SECTION 5

FAILURES OF STATUTORY PROCESS

5.1 Introduction

Figure 5.12: Extract from Studio E drawing 1279 PL400 00' Proposed Elevation, Plan & Section Detail' {HAR00010404}

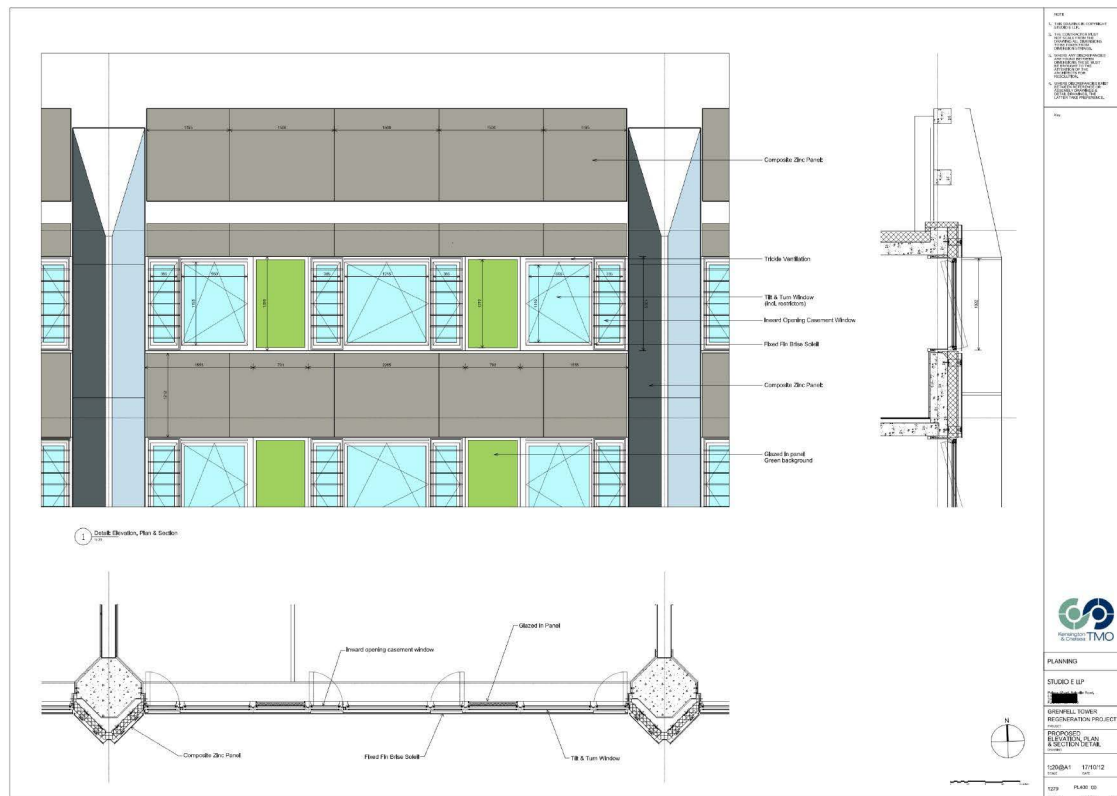
- 5.2.8 Even if this is the same drawing, I would not expect Building Control to have been provided with any drawings issued to the Planning Department for the purposes of securing planning consent, unless it was sent to Building Control by an external party (for example Studio E). I take this view because the Planning and Building Regulation Departments are effectively separate entities within a local authority and applications for consent under Planning and Building Regulations are quite separate processes. In my experience external agencies deal with the Planning and Building Regulations Departments on an individual basis, and in discharging their statutory duties in relation to the Planning Act and Building Regulations for which they are independently responsible, the departments do not have any direct dialogue with each other around an application.

- 5.2.9 However, even if such drawings had been made available to Building Control by the Planning Department, the information relating to materials shown on drawing PL 400 as apparently submitted to the Planning Department, is scant and I would not expect any queries or issues to have been raised in relation to Building Regulations compliance based on the kind of information contained therein.

Figure 5.28: Extract from Studio E drawing 1279 (08) 100 00 with RBKC P1 Comments {SEA00010243}

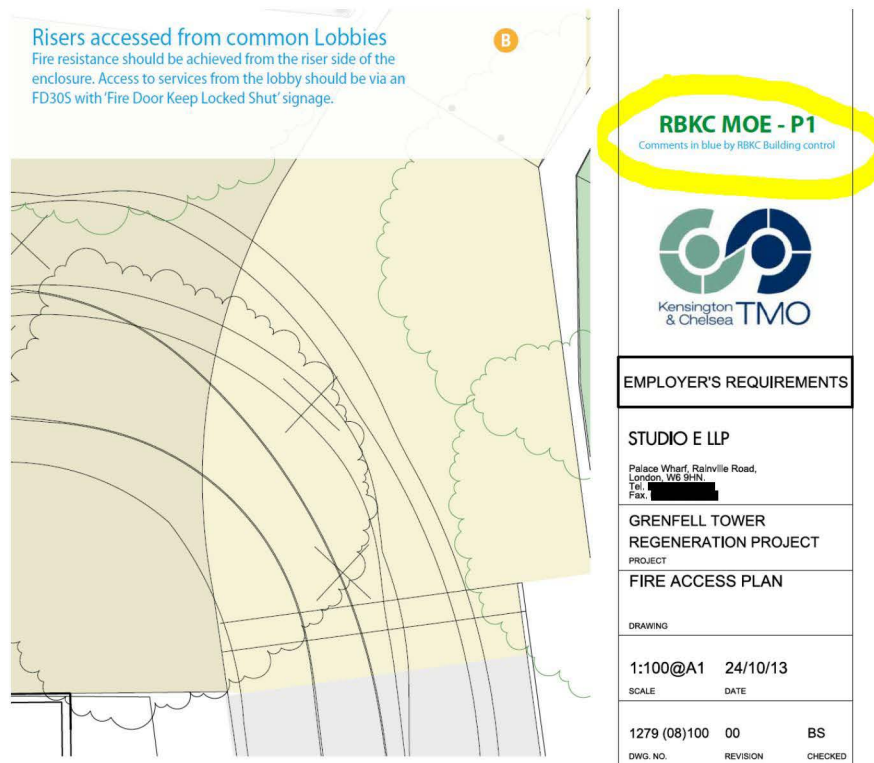
Please find attached marked up plans and observations relating to the fire strategy for the Grenfell Tower project, for your information / records.

Once you have had an opportunity to examine the attached information, please feel free to contact myself or Paul to discuss any of the points mentioned in the Councils schedule, or highlighted on the attached marked up plans.

Figure 5.47: Extract from Studio drawing 1279 (05) 100-00 'Proposed South Elevation' illustrating zinc cladding {SEA00000202}

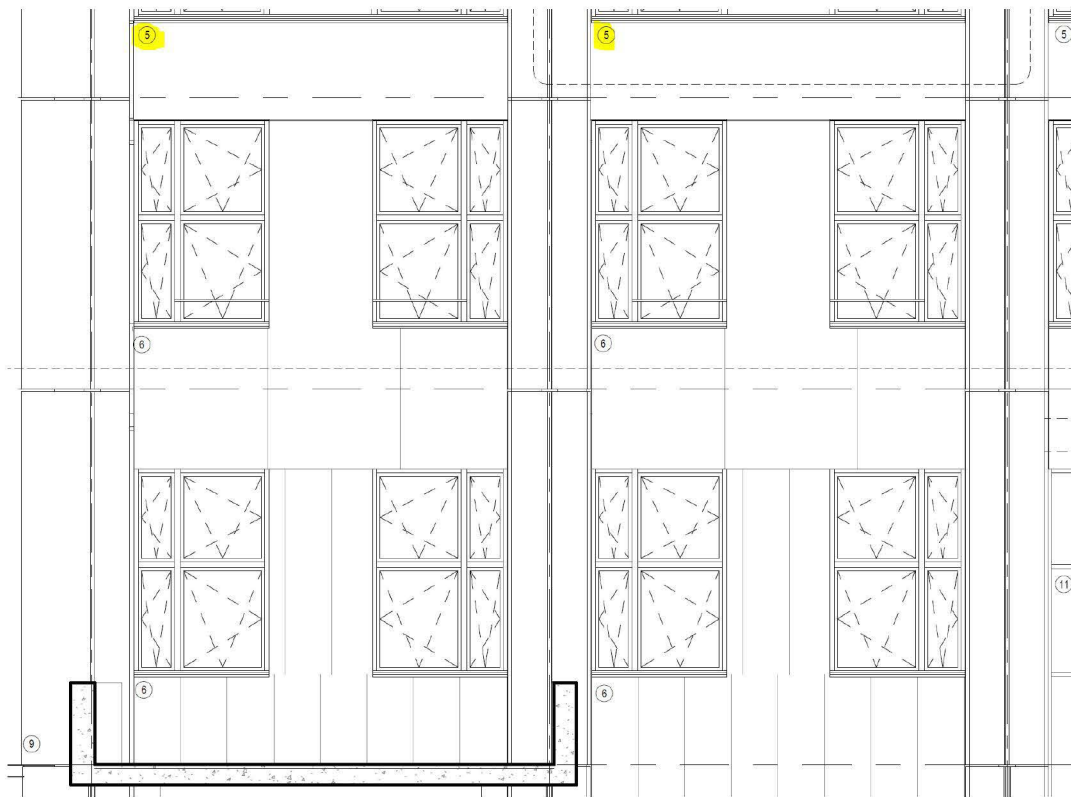
- 5.4.34 This situation can only have frustrated Building Control in terms of its duty to discharge its statutory function. Responsibility for this poor state of affairs lay, at this time, squarely with Rydon as Design and Build Contractor, and with the novated architect Studio E.

Figure 5.63 Extract from Harley Drawing 855 C1059-301-E {HAR00003958}

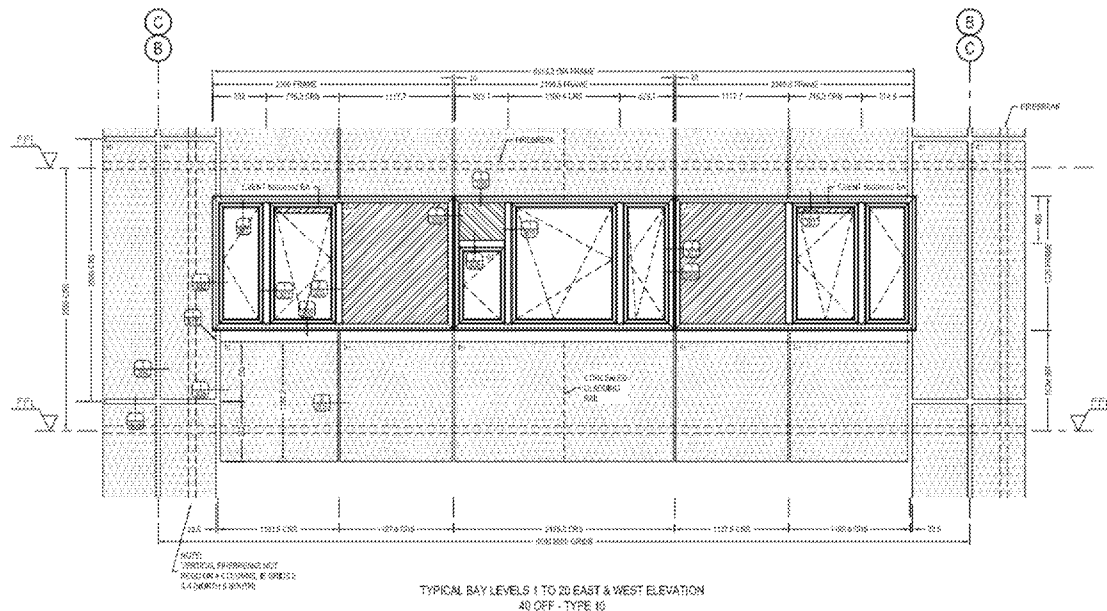
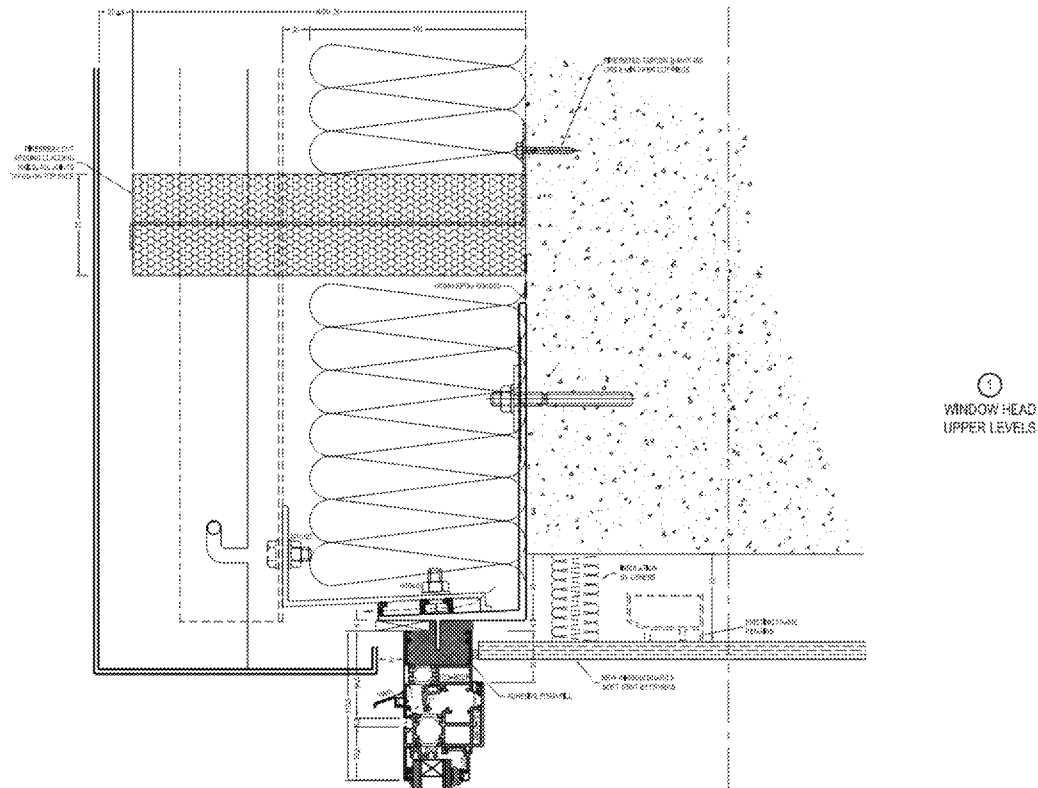
5.4.57 As discussed in Section 4 of this report, the above drawings show a series of fundamental errors in terms of the application of paragraphs 9.2a and 9.3a as well as Diagram 33 of ADB2 which I list as follows:

- 5.4.59 Against that context I am again critical of Building Control for not seeing fit to write to Studio E in the strongest terms stating that the status of information in relation to the over-cladding was wholly inadequate and that the matter of outstanding information, in this respect some 7 months on from the submission of the Full Plans application (without drawings), was a matter of grave concern.

- 5.4.60 The above Harley drawing (Figure 5.4.63) also highlights another notable issue: the thermal insulation to the newly formed cavity behind the rainscreen cladding is clearly shown with a graphic notation/drawing convention which is generally known and accepted within the construction industry to represent mineral wool. (I exhibit the same drawing below with the insulation highlighted in yellow). In this respect Harley, in preparing this drawing, appear to have erred by breaching graphic convention and misrepresenting Celotex/PIR as mineral wool because they had received Studio E's tender specification which called for Celotex RS5000 and therefore should have depicted a rigid board product. What is important is that I have seen no evidence that Building Control ever received any drawing or specification that provided written reference confirming what kind of product/material was being proposed.

Figure 5.64: Extract from Harley Drawing 855 C1059-301-E {HAR00003958} marked up to show thermal insulation as denoted by conventional graphic representation

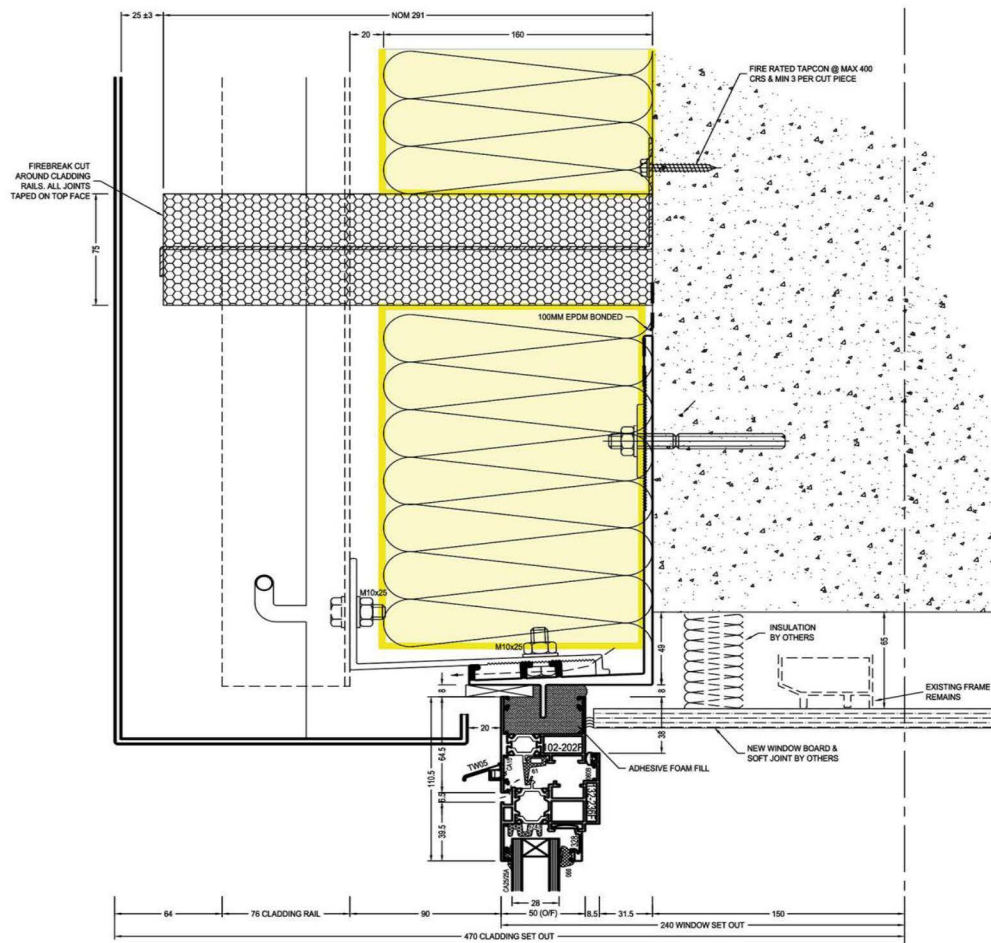
- 5.4.62 From this I deduce that, despite the lack of information on the insulation type received prior to the inclusion of Harley drawing 855 C1059-301-E (as shown in the exhibit above) within Mr Crawford's email of 6 March 2015, Mr Hoban at some time, either before or after receipt of that drawing, chose to investigate Celotex RS5000 in terms of its acceptability for this application. Such inquiry (*'I looked up the insulation'*) seemed to take the form of research of the manufacturer's product information. In this same paragraph Mr Hoban states that he received advice *'that the cladding would comply with the standards set out in the Approved Document B'*. I am critical of Mr Hoban in this respect for failing, as a Building Control Officer, to seek and secure more robust proof, in the form of independent documentary evidence, that the proposed insulation did comply with the guidance of ADB2 in terms of being a product of *'limited combustibility'*.

- 5.4.65 Clearly Building Control had not been supplied with adequate information in a timely manner, and the applicant (Rydon) and its agent (Studio E) should both be severely criticised in this respect. However, in circumstances where the information as supplied by Studio E in support of the application was clearly so inadequate Mr Hoban should not have accepted inappropriate information from other sources. And he should have known that as a PIR product Celotex RS5000 would not meet the standards required of a material of *'limited combustibility'* as defined under ADB2.

Figure 5.69 Extract from Studio E Drawing 1279 (06) 120 – 00 'Detail Section – Sheet 1'
{SEA00002551}

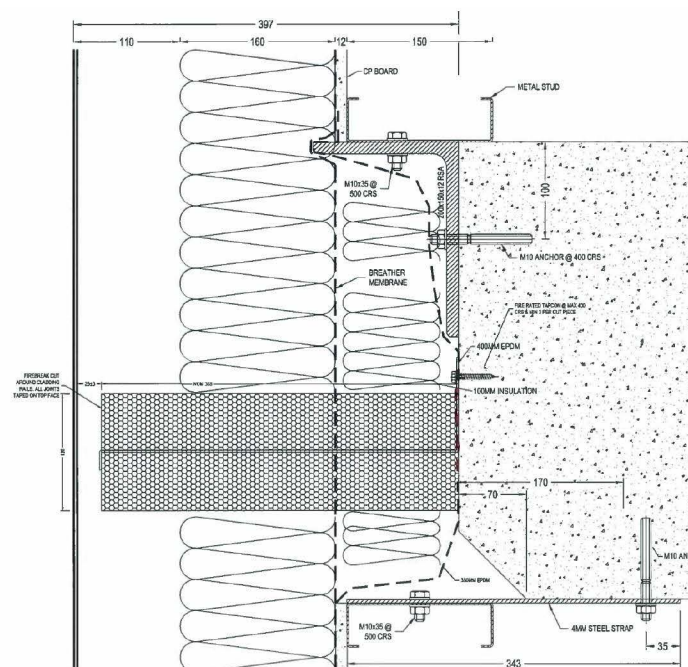
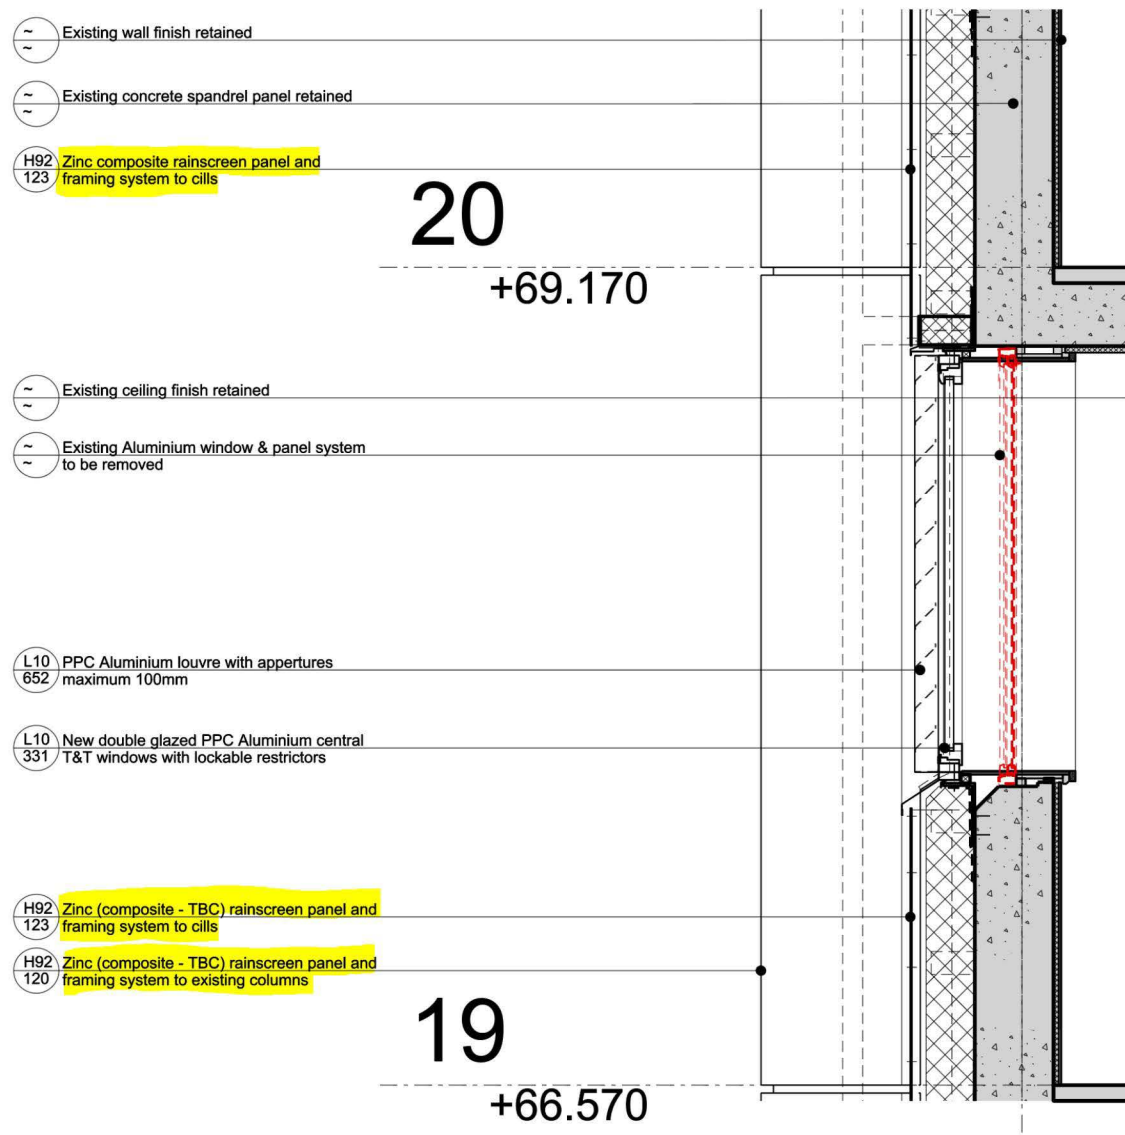
I would advise you that I have no adverse comments to make on the cladding proposals shown on your drawings 1279 (06) 120 rev. 00, 121 rev. 00 and Harleys drawing C1059-325 rev. C with regards to compliance with Parts B2 and B3 in Schedule 1 of the building regulations.

May I take this opportunity to remind you that the new *elements of structure* being erected, must be capable of resisting the action of fire for at least 120 minutes. In this connection, I would draw your attention for the need to protect the new steelwork supporting the new gallery floors shown on drawing 1279 (06) 121 rev.00 to that standard.

- f) Mr Hoban makes no comment on the fact that the Studio E drawings attached to that email refer to *'Zinc composite rainscreen panel'* (as high-lighted) in my exhibit whereas he (and Building Control) should have been aware that the rainscreen cladding had been proposed as ACP (*'aluminium composite panel, smoke silver metallic Duragloss 5000 Satin'*) as confirmed by the Harley Specification Sheet C1059-100-A already in its possession and as sent by Mr Crawford on 6 March 2015 {HAR00003955}.
